ITEM 4. DEVELOPMENT APPLICATION: 1 HUTCHINSON WALK AND 6A VICTORIA PARK PARADE ZETLAND**FILE NO:** D/2011/1818**DEVELOPMENT APPLICATION NO:** D/2011/1818**SUMMARY****Date of Submission:** 9 November 2011

Applicant: Henlia No. 21 Pty Ltd**Architect:** Turner & Associates**Proposal Summary:** The subject application seeks consent for a Stage 2 development application for the detailed design of 5 residential apartment buildings ranging in height from 6 to 15 storeys, and encompasses the following:

Figure 9 - The building heights (in storeys) for the site as detailed in the 1998 Masterplan (left) and as amended by the 2003 Masterplan (right).

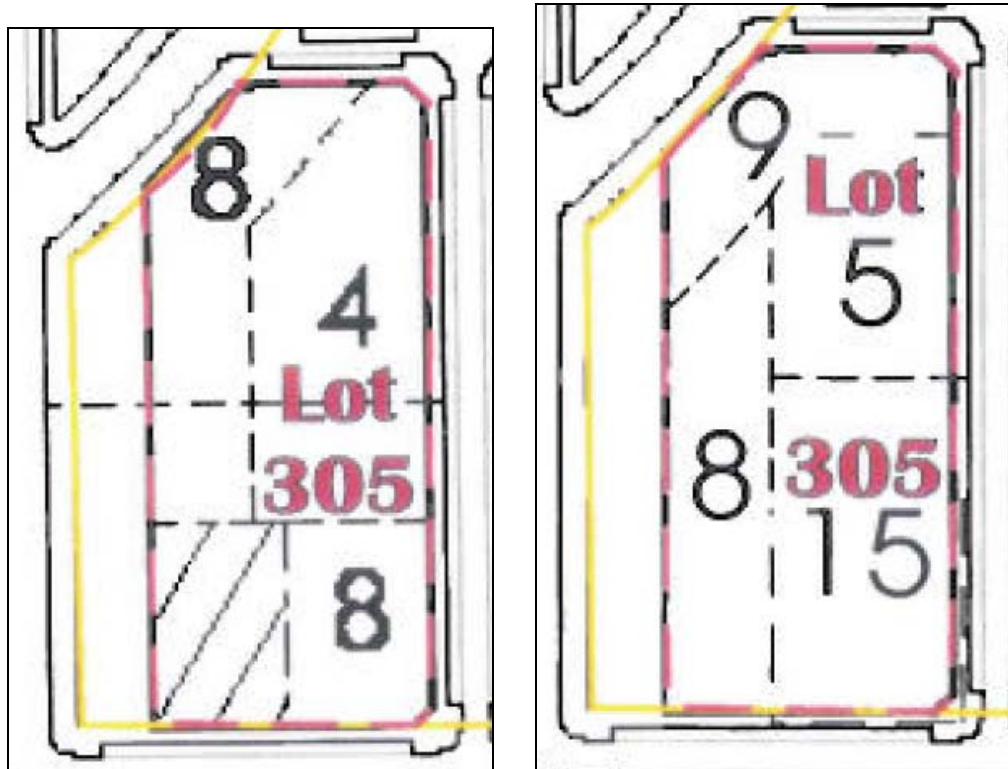
12. **Figures 9 and 10**, below, illustrates the variation in building heights that resulted on the subject site from the 2003 amendments to the Victoria Park Masterplan.

Generally, the massing and heights of the five buildings reflect the desired built form of the Refined Masterplan for Lot 305 (refer to **Figure 9**). Where elements of the proposed buildings do propose numeric variation from the Masterplan (such as Building C), the upper floors have been recessed to minimise their visibility. These setbacks ensure the integration of the buildings with the scale of existing development along the Gadigal Avenue frontage of the site. Further discussion on the consistency of the proposed development with the Masterplan and previous consent is provided in the issues section of this report.

Figure 19 - The reduced envelope and floorplate of Building A from that approved in the previous DA scheme

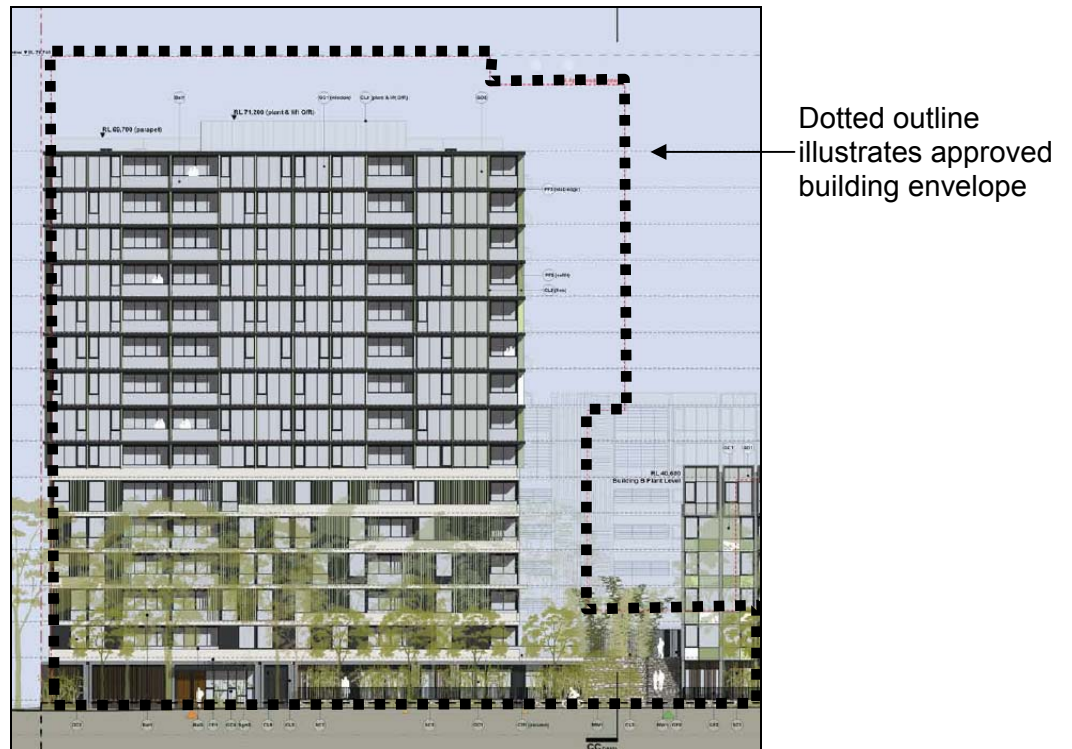
65. The proposed floor plates of the 15-storey tower (Building A) exceed the recommended maximum of 700sqm, instead are proposed at 800sqm on Levels 2 to 15. Whilst this represents a numeric variation, it should be noted that the approved floor plates for this tower within the previous DA were 850sqm. **Figures 19 and 20**, below, illustrate the reduced bulk and scale of the proposal from that the Anglican Retirement Village scheme approved in 2010.

Figure 21 - The internalised car park screened by perimeter residential dwellings at ground floor level

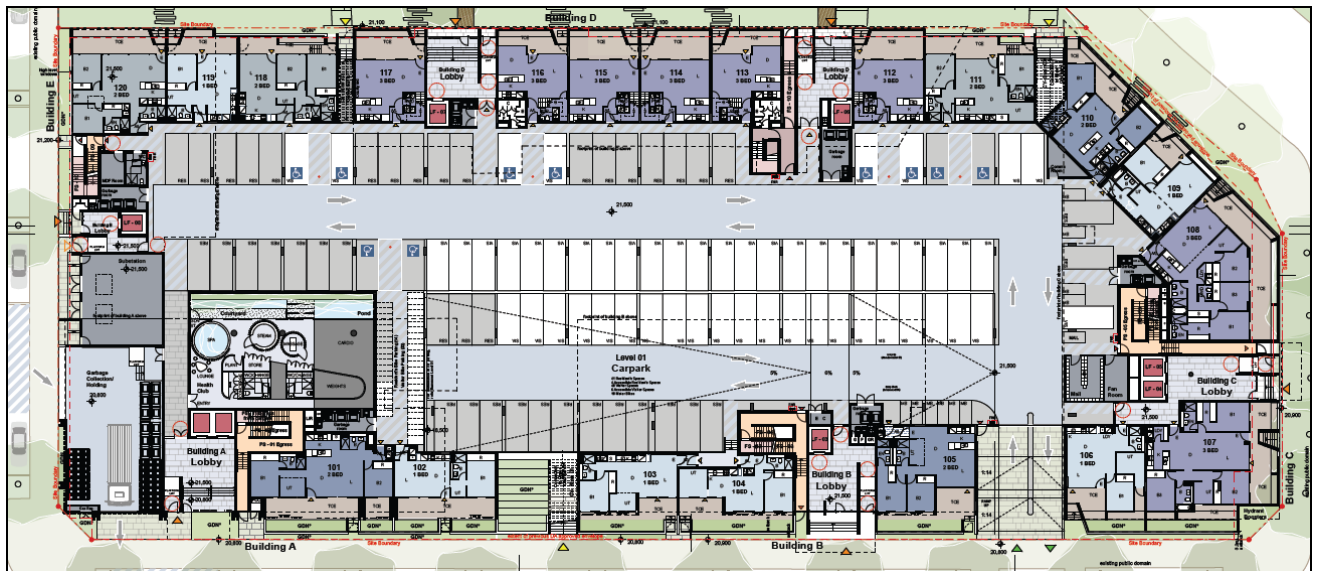
67. The proposed development has been designed as a perimeter building form, with the car parking located within the centre of the site, such that the car parking areas are not visible from the public domain surrounding the site.

68. This results in a site coverage of 96% (on Lot 305 only) which exceeds both the maximum site coverage provision of 65% contained within the Victoria Park Refined Master Plan Amendment 2003, and the requirement of the Council resolution to locate deep soil areas within the centre of the site.

Figure 24 - The proposed garbage storage and collection room and vehicular egress requirements from Kirby Walk and George Julius Avenue.

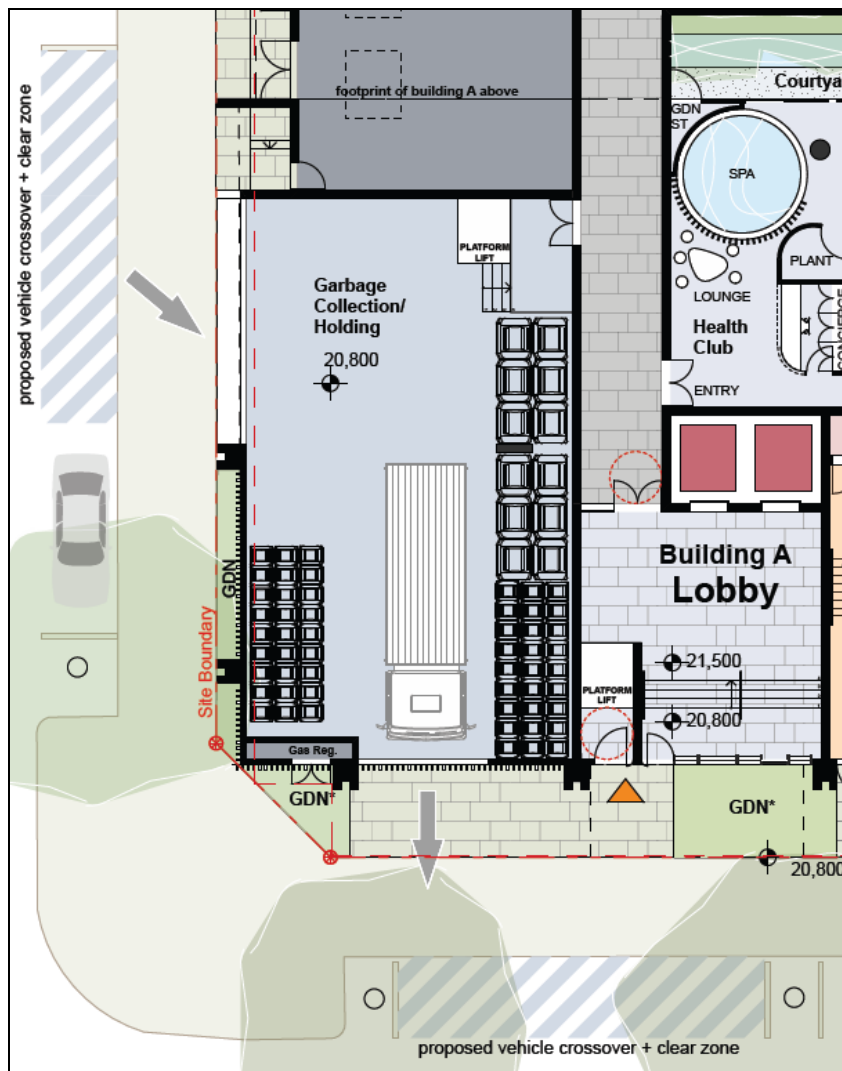
77. In its revised form, the proposal includes a garbage storage and collection room within the southeastern corner of the development, at the intersection of Kirby Walk and George Julius Avenue. **Figure 24**, below, illustrates the proposed garbage room configuration.

78. Whilst the provision of these facilities on-site is supported, it is considered that further design resolution is required to delete the vehicular access to George Julius Avenue to minimise impacts to the public domain and maintain on-street car parking. Instead modifications are recommended to the garbage room, included provision of a turntable to allow entry and exit via Kirby Walk. A design modification condition has been recommended for imposition to this effect.

- f. Swept path analysis prepared by a suitably qualified Traffic Engineer, shall accompany the amended plans illustrating the vehicle entering and exiting the garbage collection room, as well as a clear path of rotation for the vehicle when on the turntable.
